February 20, 2025

Re: Incidental Take Permit Application for the Desert Tortoise; Draft Habitat Conservation Plan and Draft Environmental Assessment; Overnight Solar Energy Project, San Bernardino County, CA (Docket No. FWS-R8-ES-2024-0160)

Figure 1. Location of the proposed Overnight Solar Project (blue), gen-tie line (black dashed & red lines), and access roads. Part of the Plan Area is indicated in tan stippling.

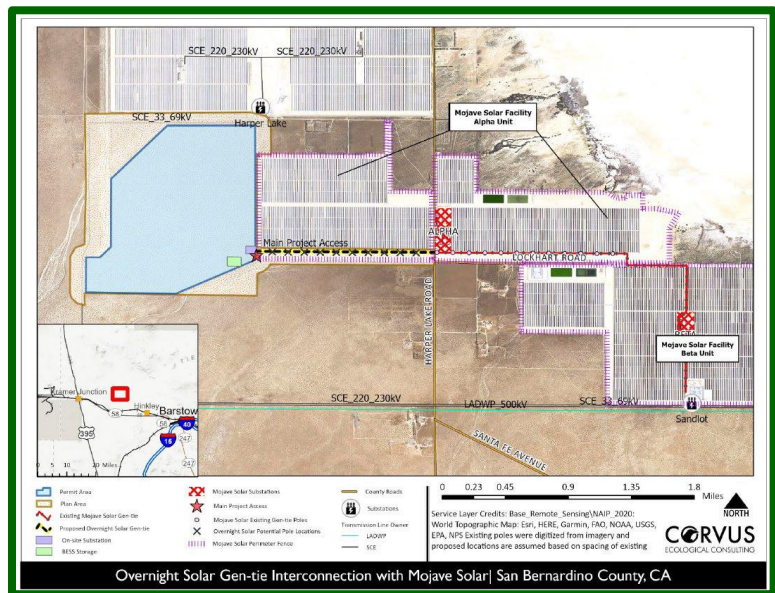
Figures delineating the Permit Area and Plan Area: Based on the information in the environmental assessment (EA) and in the Habitat Conservation Plan Handbook (USFWS and NMFS 2016), the Permit Area is where the incidental take authorization applies and the Plan Area or HCP area, is all areas that will be used for any activities described in the HCP, including covered activities and the conservation program. It includes all lands necessary for the HCP to be fully implemented. We believe that Figures 3 and 4 of the EA are incorrect in their delineation of the Plan Area and Permit Area. The figures show the Permit Area as limited to the construction areas of the Project and the proposed translocation area as in the Plan Area. The translocation area involves incidental take of tortoises – tortoises will be handled during their initial release at the translocation area and again during monitoring. Hence, the translocation area is in the Permit Area. The mitigation lands in Figure 3 appear to be located outside the Plan Area. Please correct these two figures to show that the proposed translocation area is in the Permit Area and the proposed mitigation lands are in the Plan Area. Please see our comments below on fencing the mitigation area under “Enhancement of the Mitigation Lands.”

Page 3, Figure 1: We believe the Plan Area and Permit Area shown on this figure are incorrect. The mapped location of the Plan Area does not include the mitigation lands, and the mapped location of the Permit Area does not include the Translocation Area. Please refer to our comments on the EA under “Figures delineating the Permit Area and Plan Area.”

Figure 2. Proposed location of mitigation lands (red) to be managed for the tortoise and location of the proposed solar project (blue).

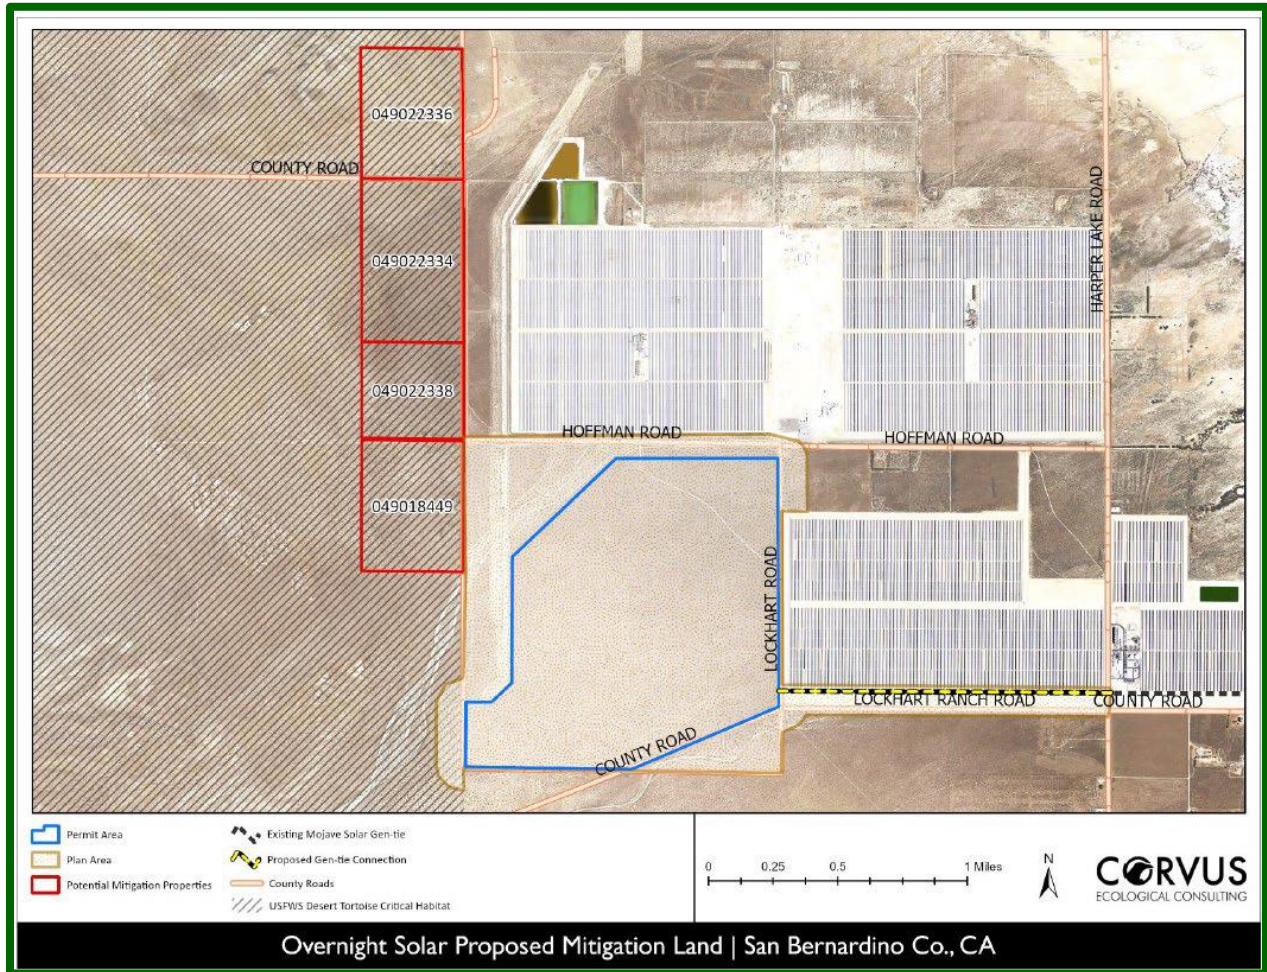
Additionally, we found no information about the land ownership for the potential mitigation lands indicated in Figure 2. Mitigation lands should not be located on BLM land because of their mandate under the Federal Land Policy Management Act (FLPMA) to manage lands for multiple use. Thus, BLM lands cannot be managed for the conservation benefit of the tortoise in perpetuity. Please add this land ownership information in the Final EA along with who will be responsible for implementing the management of these mitigation lands for the conservation benefit of the tortoise, what assurances would be used to provide for the management of the mitigation lands in perpetuity for the conservation of the tortoise, and whether the lands would be fenced. Fencing may result in incidental take, and if so, the mitigation lands or the location of the fence should be included in the Permit Area and the construction and maintenance of the fence a covered activity.

Figure 3. Location of translocation area (black hatched area) and tortoise burrows (green circles).

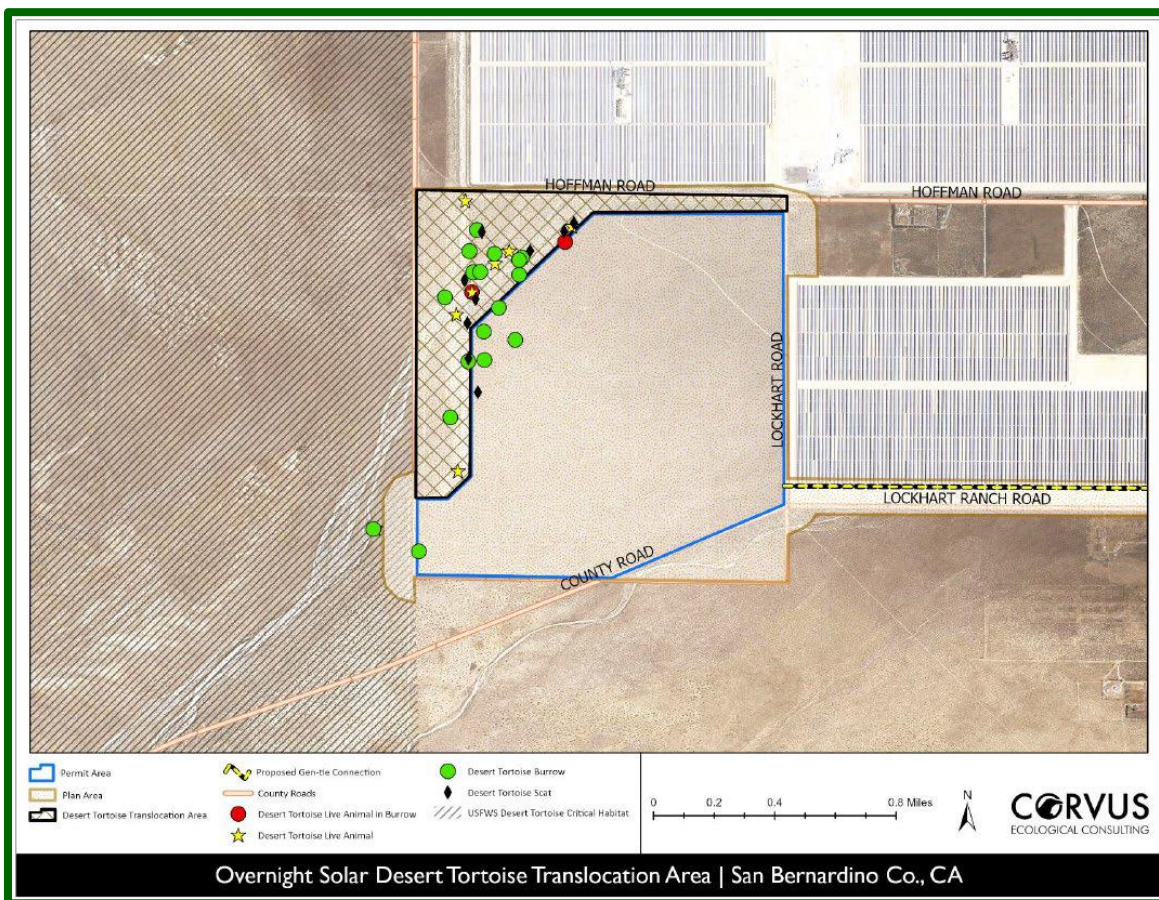
Page 18, Translocation Recipient Sites: “Translocation of MDT to the approved recipient site is a covered activity of this HCP.” The discussion in this section is for one recipient site and “Figure 3. Overnight Solar Mojave Desert Tortoise Translocation Area” delineates one recipient site. The title of this section is plural suggesting more than one site. Please clarify if there is more than one recipient site being considered for translocated tortoises, and if so, where the other site(s) is/are located.
